U.S. NUCLEAR REGULATORY COMMISSION

Reports No. 50-282/90004(DRP); 50-306/90004(DRP)

Facility Name: Prairie Island Nuclear Generating Plant

Inspection Summary

## 2 GENERATOR BUS DUCT COOLER BLOWER CONTROL

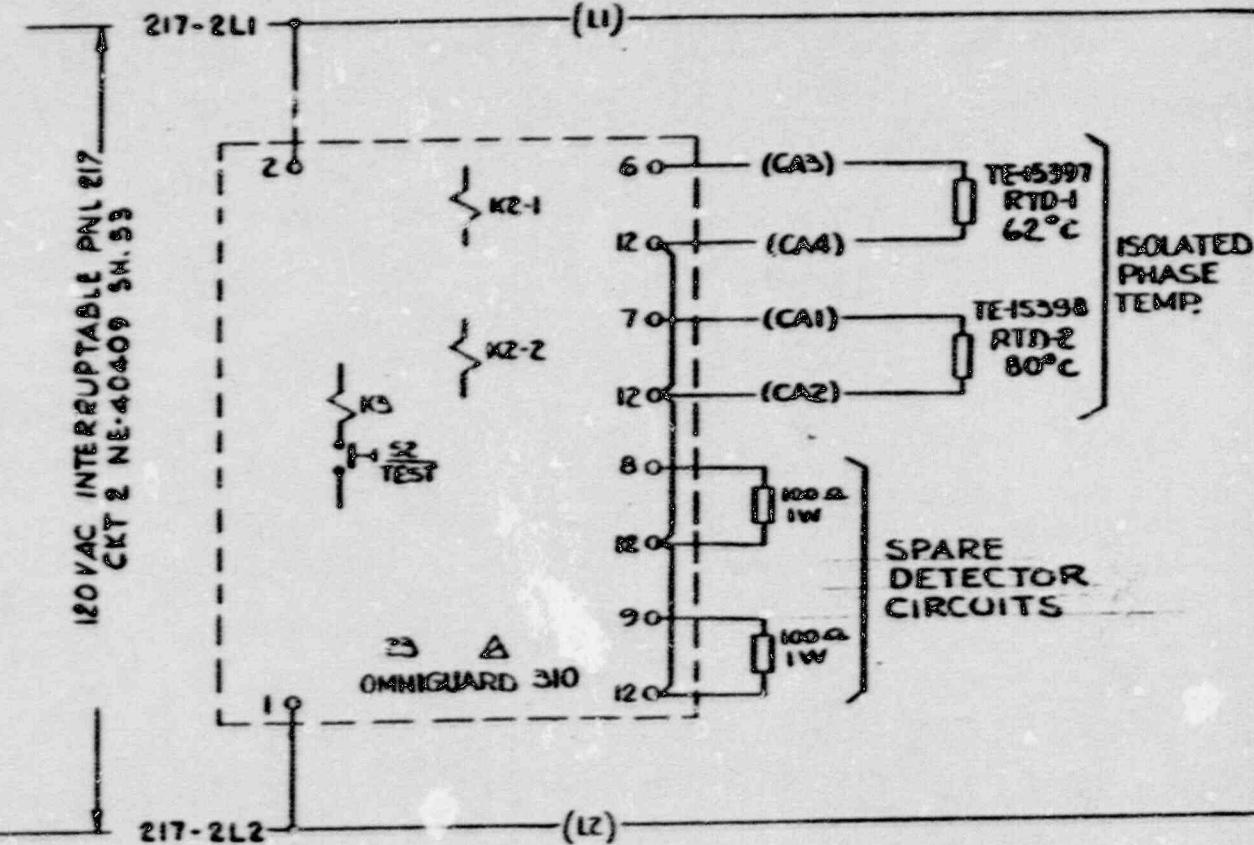
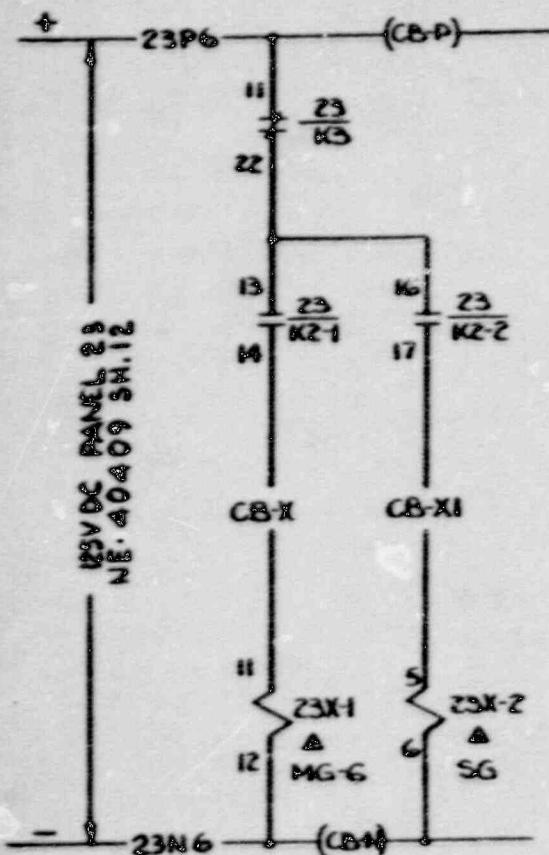
The cause of the turbine trip at 100% power was a generator lockout signal generated at the generator bus duct cooling control panel. The lockout signal was generated when an operations instructor depressed the panel test push button. Depressing the test push button energizes the K3 relay (the attached schematic diagram). When the K3 relay is energized, a "b" (normally closed) contact (K3-23) in the "generator lockout power supply" should open, thereby preventing the generator lockout relay (23X-2) from being energized. Additionally, during actuation of the test circuitry an "a" (normally open) contact on K3 closes which provides power to the K2-1 and K2-2 relays. When relays K2-1 and K2-2 are energized, "a" contacts K2-1 (23) and K2-2 (23) close, and would energize relays 23X-2 and 23X-1,

if contact K3-23 were closed. Energization of relay 23X-2 would cause a generator lockout (setpoint 85 degrees C sensed in the bus duct). Energization of relay 23X-1 would cause the autostart of a second bus duct cooling fan to occur (setpoint 60 degrees C sensed in the bus duct).

When the test button was depressed all functions occurred as designed except the K2-23 "b" contact remained closed. Once K2-2 was energized (by K3), the K2-2 (23) contact closed and energized the 23X-2 relay, causing the generator lockout.

The root cause of this equipment failure appears to be age. The equipment was installed during initial plant construction. In response, the licensee has electrically disarmed the test push button on Unit 2. The Unit 1 test button is SECURE CARD tagged against usage. The test push button performs no valuable function other than illumination of test lights which indicate the K2-1 and K2-2 relays are energized. The setpoints for the 23X-1 (second) bus duct cooler fan autostart and the 23X-2 (generator lockout) which are based on bus duct temperature, receive calibration during every refueling outage.
